HICKORY (ROVE BAPTIST CHURCH

SUBJECT: Administrative Approval for Petition No. 98-73, Hickory Grove Baptist Church.

REZONING
PETITION
98-73
For Public Hearing

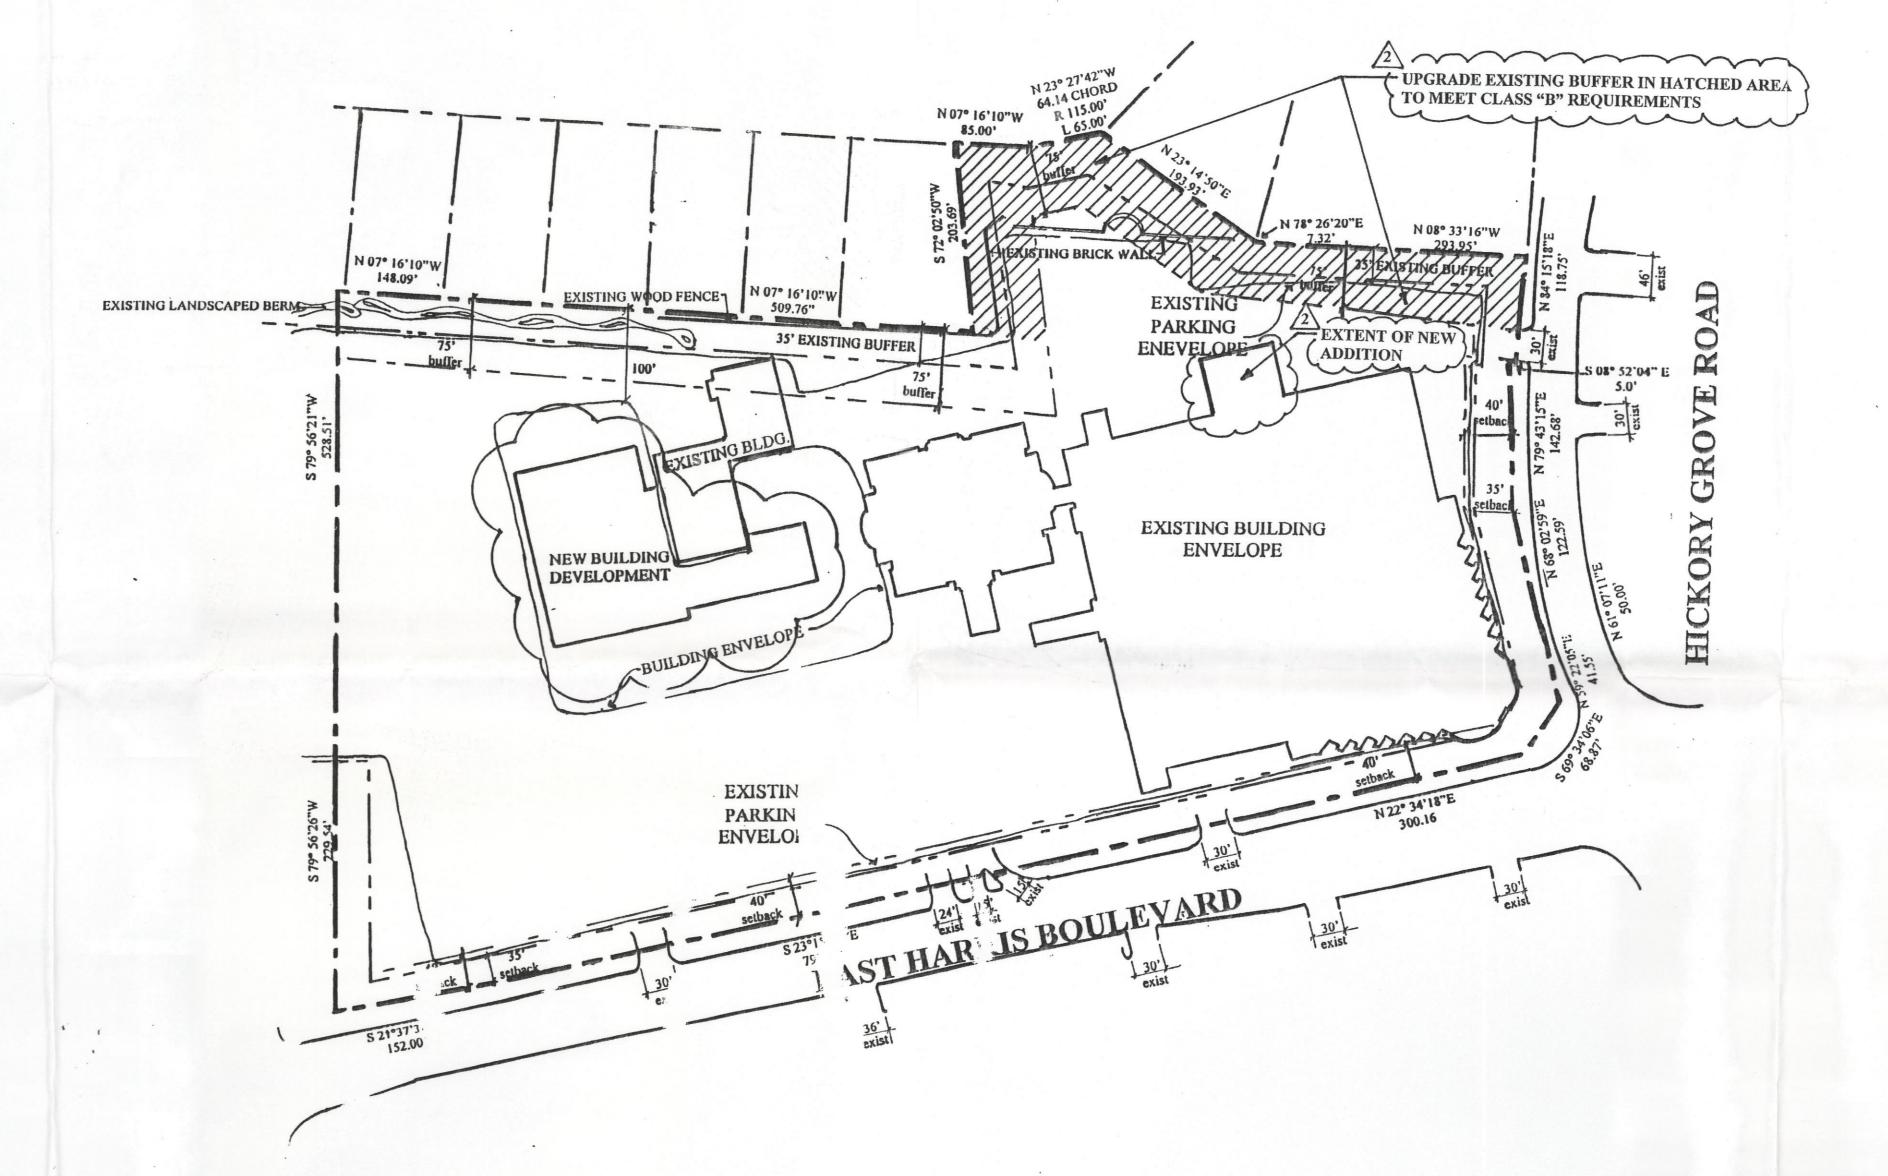
Attached is a revised site plan for the above petition showing a small expansion to the existing building envelope and an upgrade to the existing buffer along the southwestern property line. This approval will also clarify that the height limitations and building square footage limitation only apply to the area labeled "New building development" on the southeastern portion of the site. Since this change is minor, I am administratively approving this revised plan. Please use this revised plan when evaluating requests for building permits and certificates of occupancy.
